Department of Transportation, Infrastructure and Energy

General Provisions and Contract Specifications for Highway Construction

SPECIFICATIONS: Current Status Date: January 2019

Revision #26

FIGURE 301-01 INLET GRATE (N.T.S.) REVISED 2019

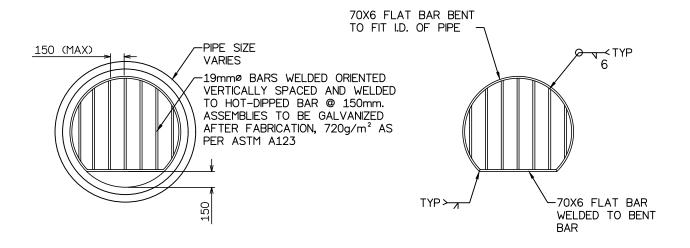
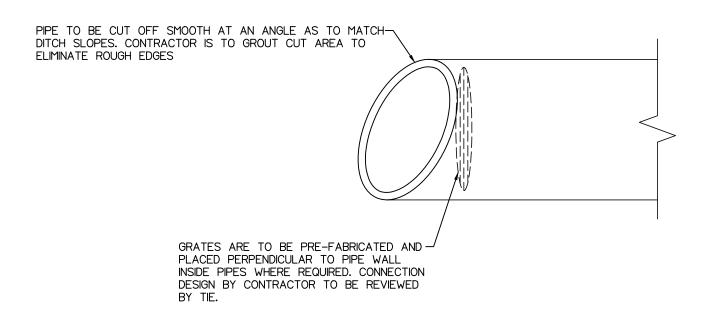
301-01 Updated figure 301-01 Inlet Grate

FIGURE 301-02 OUTLET GRATE (N.T.S.)
REVISED 2019

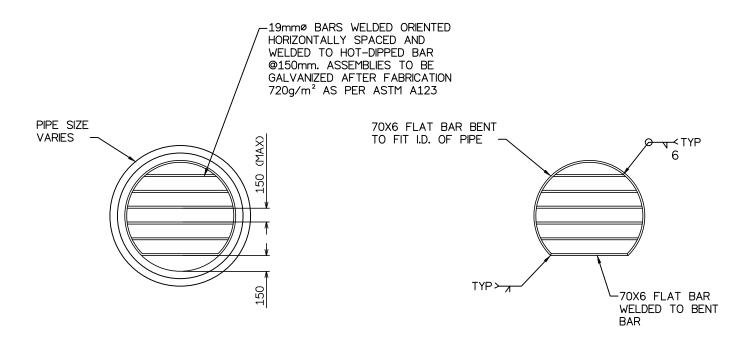
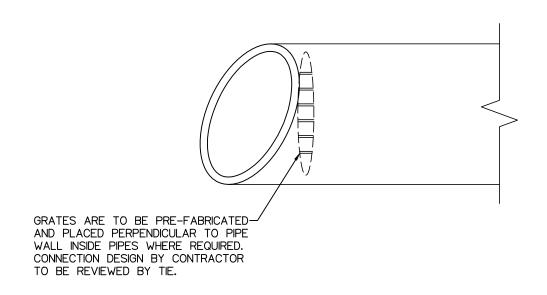
301-02 Updated figure 301-02 Outlet Grate

FIGURE 303-01 ADJUSTABLE MANHOLE COVERS (N.T.S.)

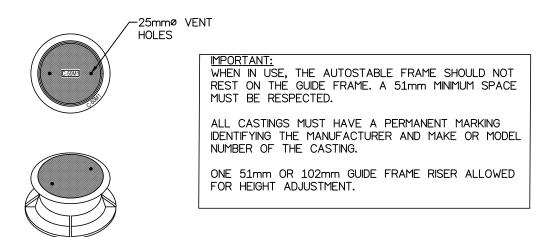
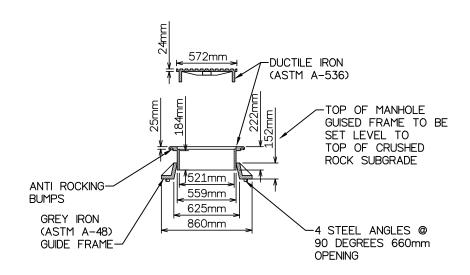
303-01 New figure added for adjustable manhole covers

Adjustable manhole frames and covers shall be C-50M1 Cone Shaped Frame / Autostable as manufactured by Bibby-Ste-Croix, or approved equivalent, meeting the requirements of CSA B70.1 and shall be as shown on Detail Drawing No. 303-01.
